Service Letter: 448, Initial Revision

Title: 8KCAB Loading Schedule

Models: 8KCAB 180HP Serial Numbers 761-95 to 1177-2018

Figure 1, Superseded Loading Schedule

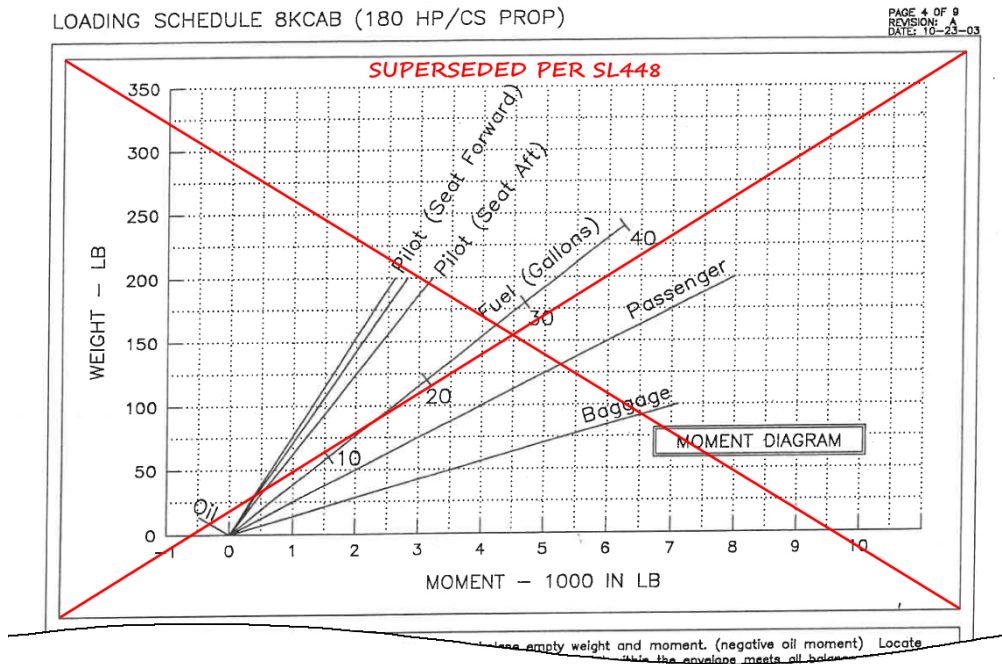
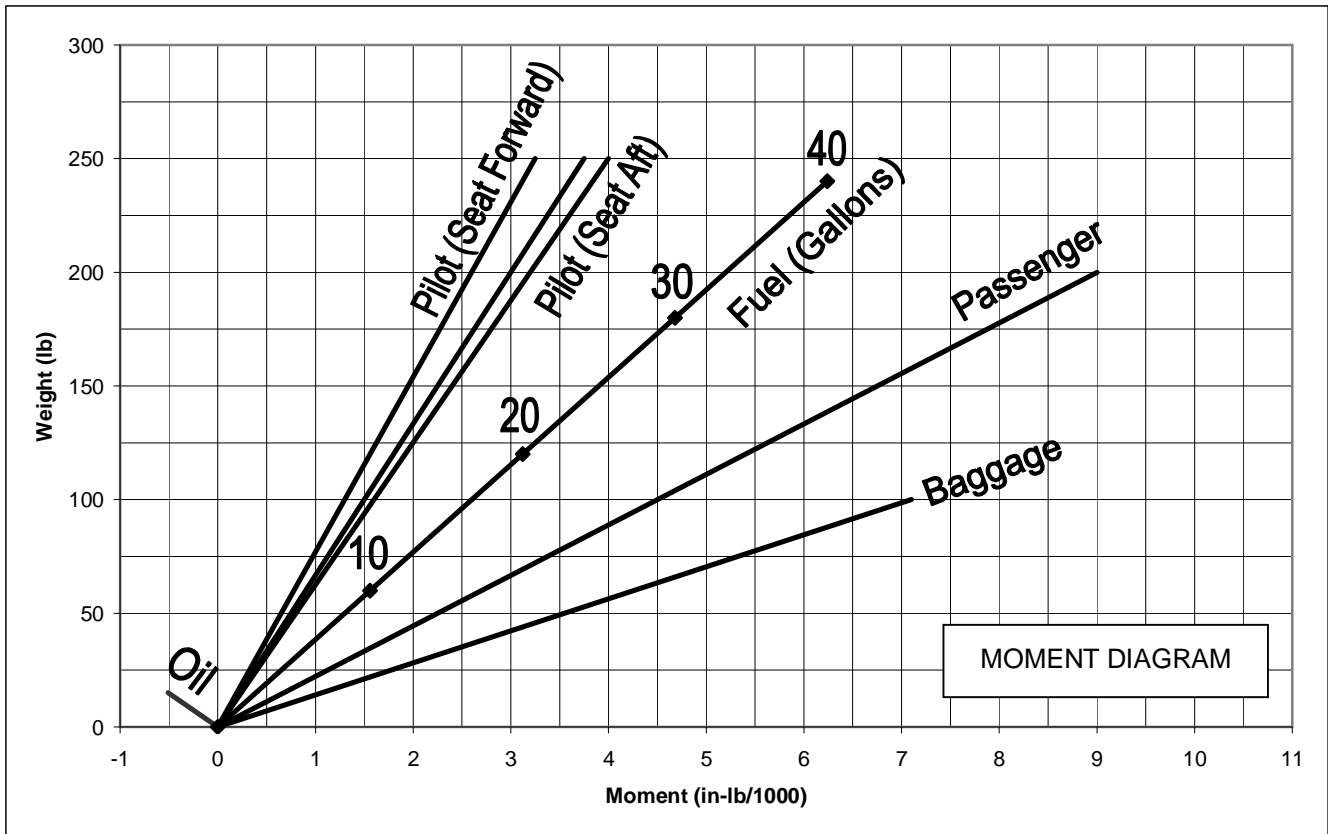
Description: The moment diagram provided in the ACAC Addendum to the Airplane Flight Manual is error with regard to the rear passenger moment. This service letter provides instructions to remark or replace the moment diagram.

1. Locate the loading schedule in the ACAC Addendum to the Airplane Flight Manual. Verify the date of the loading schedule page; if dated 11-21-95, 3-5-96, or 10-23-2003 proceed with step two. If otherwise dated verify the line for the passenger passes from 0lb & 0in-lb to 200lb & 9000in-lb on the moment diagram.
2. Mark the moment diagram portion of the loading schedule as superseded per SL448; appropriate marking is shown below. Insert page two of this service letter ahead of the loading schedule in the ACAC Addendum. Alternately the moment diagram can be remarked such that the line for the passenger passes from 0lb & 0in-lb to 200lb & 9000in-lb.

- Revised loading chart added to ACAC Addendum to the Airplane Flight Manual per SL448, initial rev., dated 5-21-2018.
